RE: Uranerz Energy Corporation, Nichols Ranch Project, Source Materials License SUA-1597, Docket No. 40-9067, License Condition 12.8 Request for Additional Information Response

**Uranerz Energy Corporation Nichols Ranch ISR Project
Responses to the NRC Request for Additional Information, Pre-operational License
Condition 12.8, February 14, 2014.**

Figure 3, Nichols Ranch Wind Rose Comparison

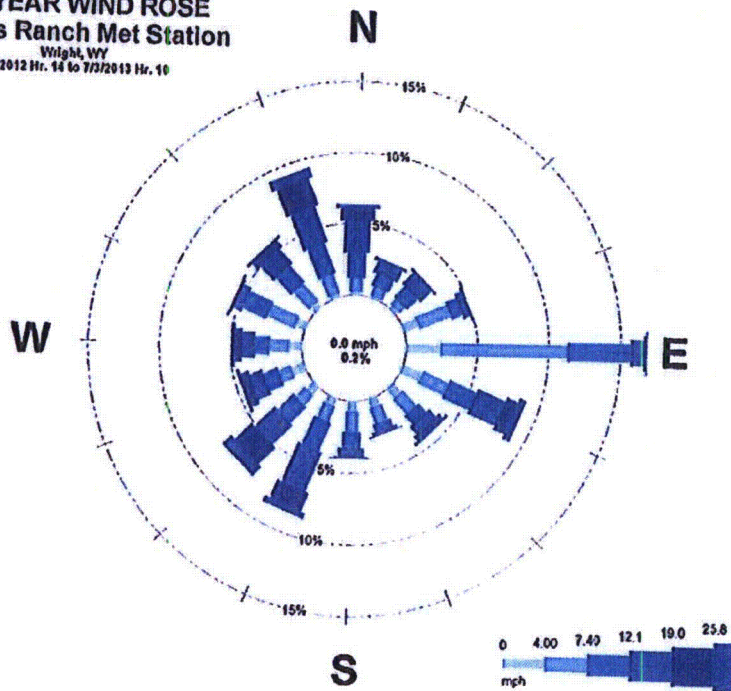
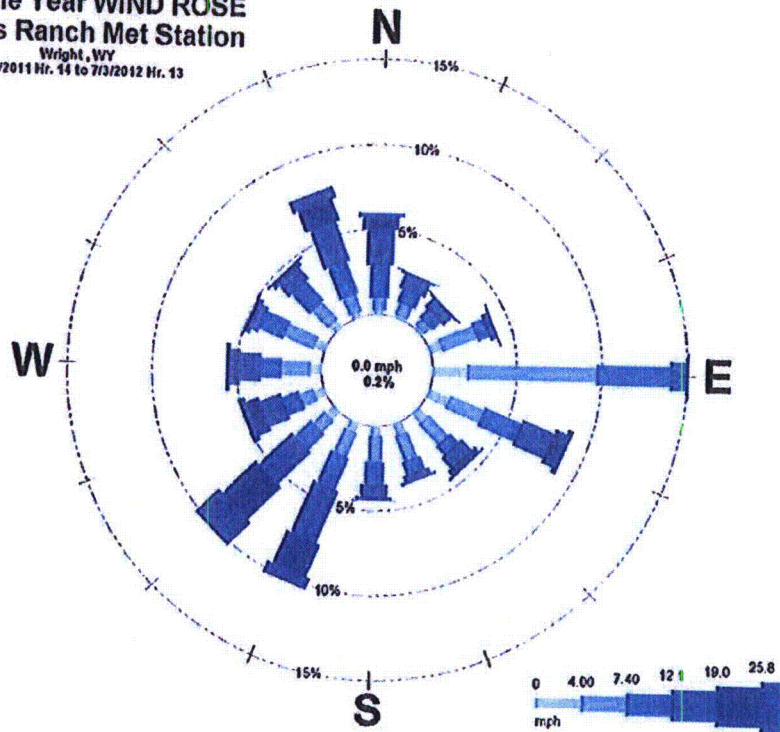
The licensee reviewed local meteorological data (see Appendix B) to meet requirements in license condition 12.7. This review was completed in order to determine if changes need to be made to environmental air monitoring stations. The review for proposed changes will take place under a Safety and Environmental Review Panel (SERP) to determine if proposed changes will meet the NRC requirements for sampling of air particulates and radon air samplers. Any approved changes must not change both basic health and safety requirements and basic potential environmental impacts assessed as part of the licensing process. The review panel will also take into account radiological considerations in order to maintain the As Low As is Reasonably Achievable (ALARA) principle.

**Figure 2-25,
Nichols Ranch Unit
Radon/Gamma/Air
Particulate Monitoring Locations**

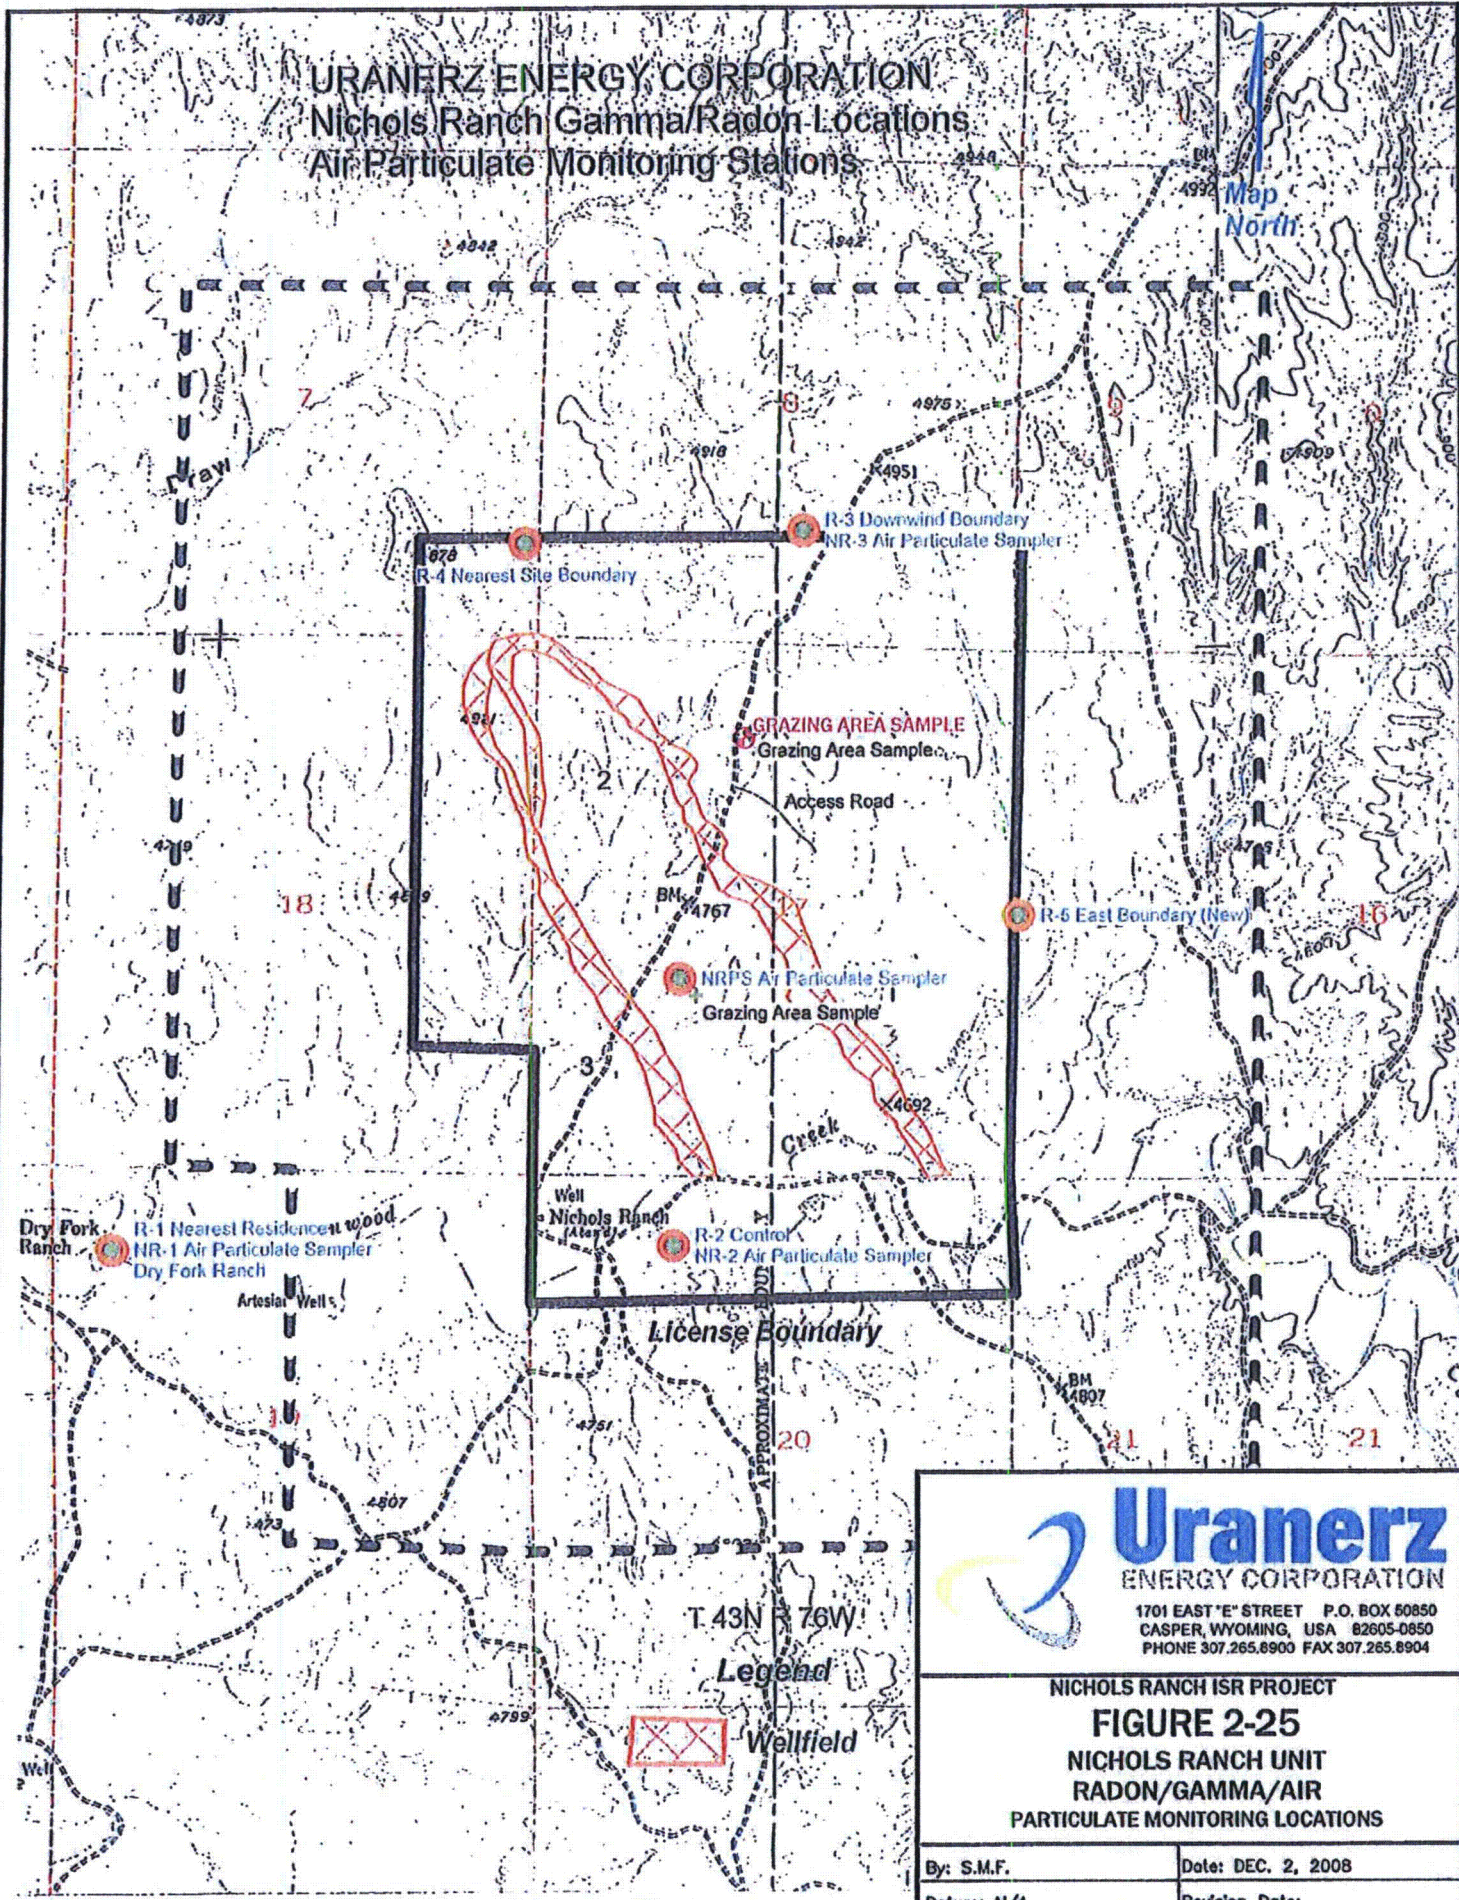
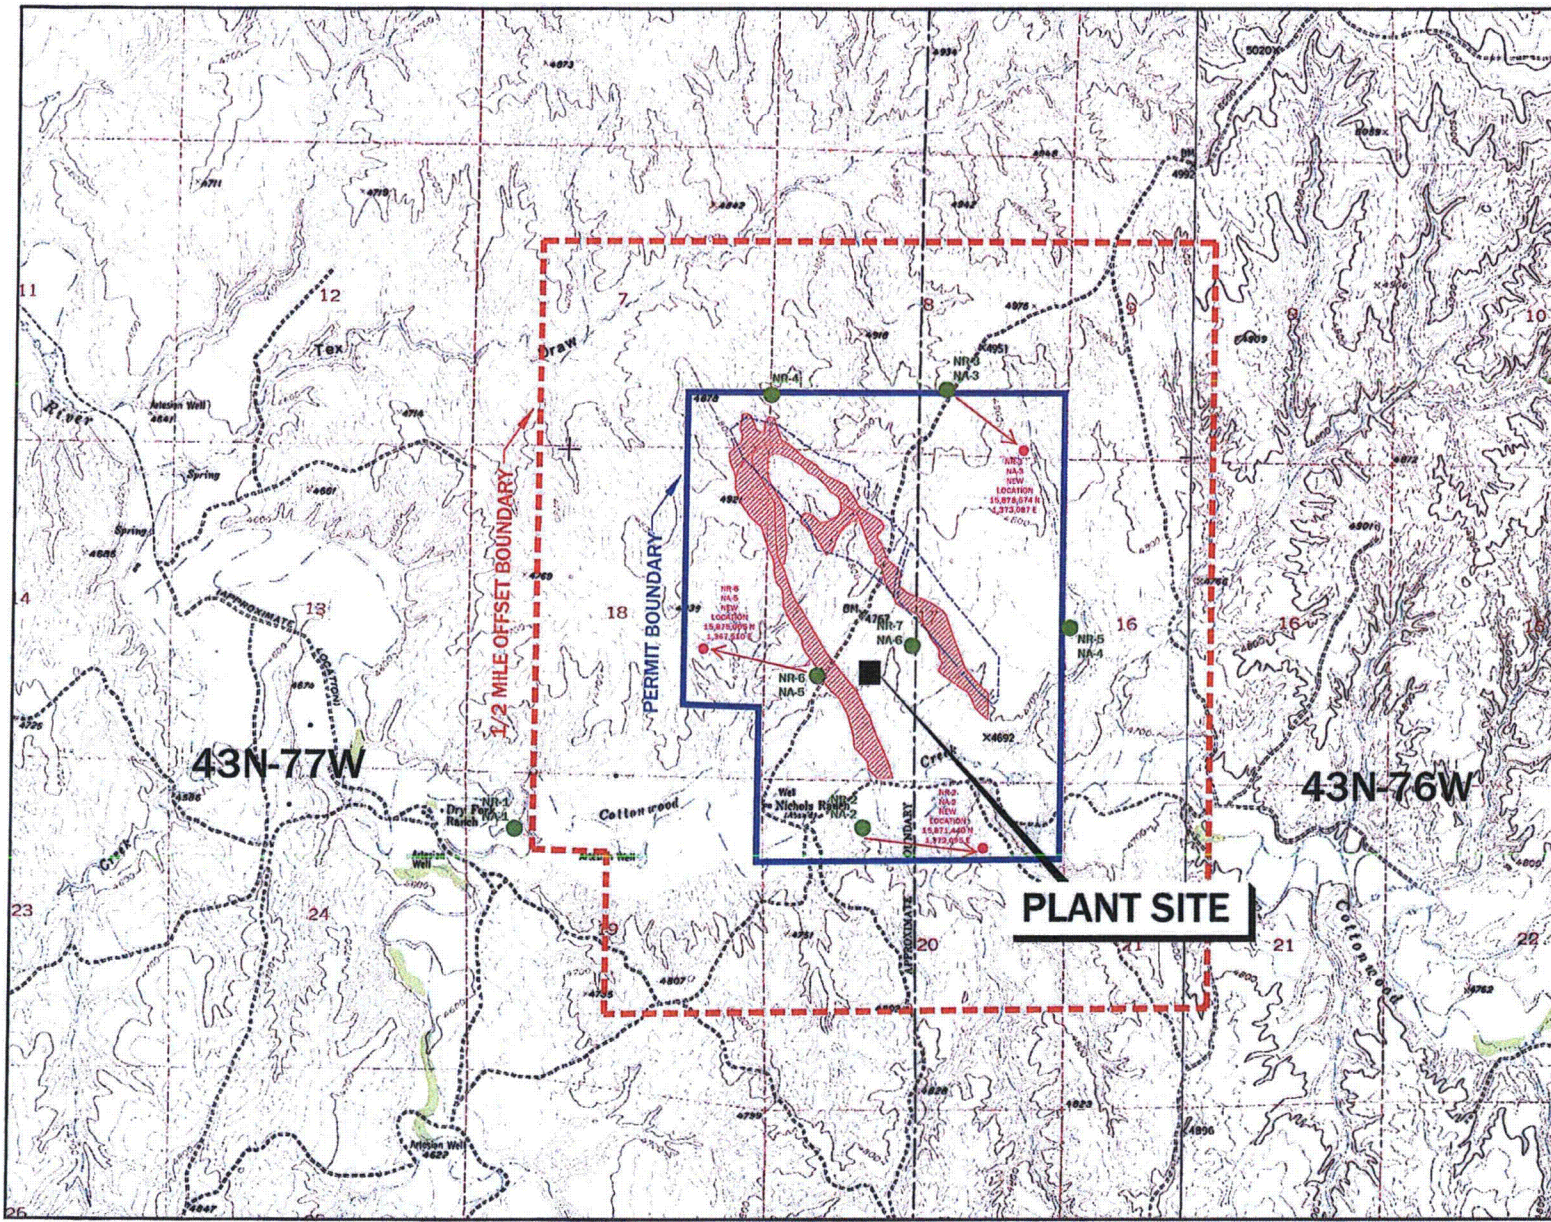
The proposed change to the license is to Figure 2-25 (see Appendix C) which is a map describing the location of baseline environmental air samplers. For a map of current environmental sampling locations see Appendix D. After review of on site meteorological data the licensee has determined that the three sectors with the highest predicted radioactivity concentrations resultant from operations is: 1) west of processing plant, 2) north-northeast of processing plant, and 3) south-southeast of processing plant. Taken this additional information the licensee has proposed new locations for environmental air samplers (see Appendix E). This change includes moving sample location NA-2 and NR-2 further to the east, moving sample location NA-5 and NR-6 closer to the western boundary, and also moving NA-3 and NR-3 closer to the northeast boundary. Another proposed change would be changing the background sample location from NA-2 to NA-4. These changes are to be implemented in order to ensure the licensee is in compliance with NRC Regulatory Guide 4.14 and license condition 11.9.

**Figure 2-25 Revision 2,
Nichols Ranch Unit
Radon/Gamma/Air
Particulate Monitoring Locations**
